Project Modifications Report – Loyalist Solar Project Version 1.2

This report has been prepared to describe the proposed modifications to the Project design since the submission of the REA application. The following sections of this REA Project Modifications Report describe the proposed Project design modifications and rationale associated with each modification.

The Proponent is proposing modifications to the Project that involve the reduction of the Project Location and resulting relocation of inverter stations, and the inclusion of additional noise mitigation.

Figure 1-1: Original Project Location**Legend**

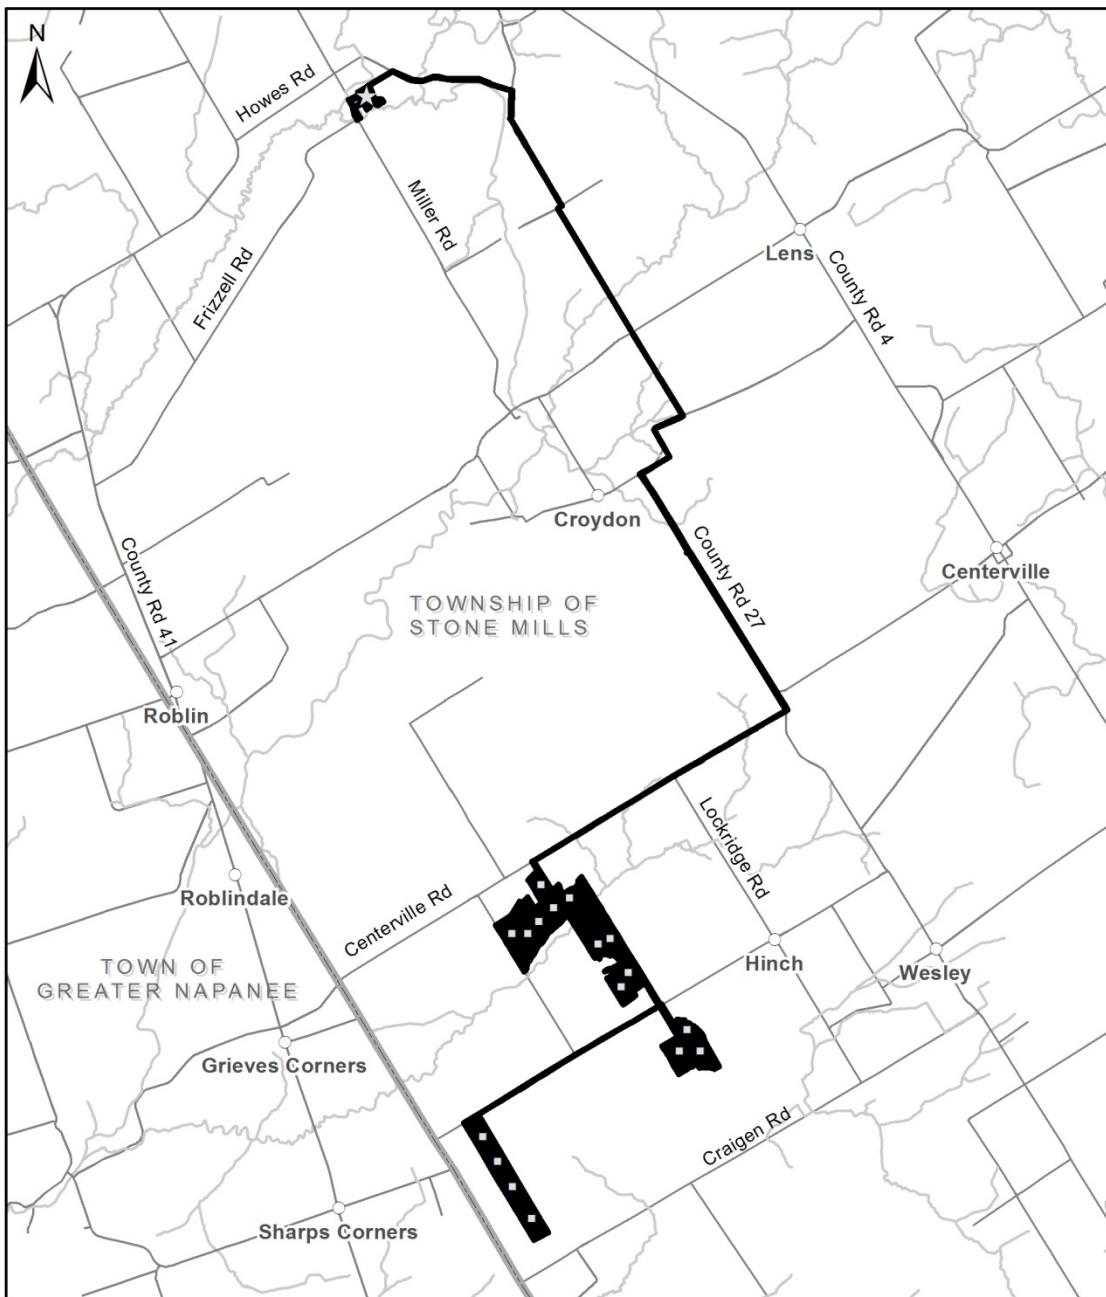
The Project Location has been reduced in size from the initial REA submission. The original Project Location is depicted in **Figure 1-1**. The modified Project Location is depicted in **Figure 1-2**.

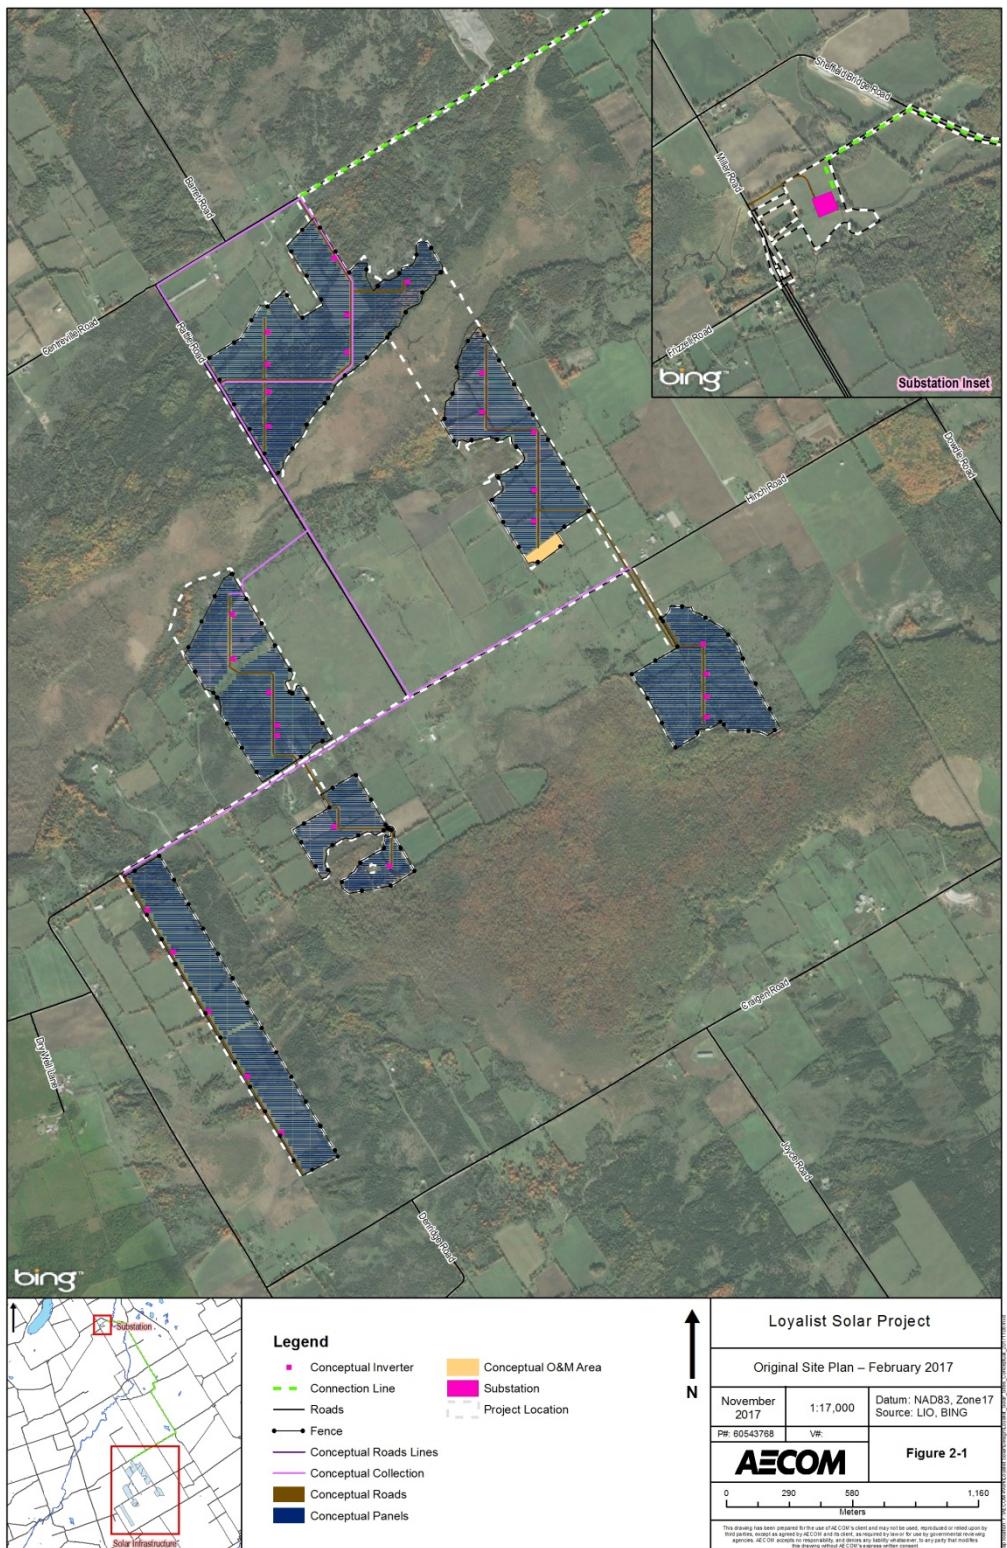
Figure 2-1 illustrates the conceptual site plan as submitted as part of the REA application in February 2017, **Figure 2-2** demonstrates the changes resulting from the proposed modifications.
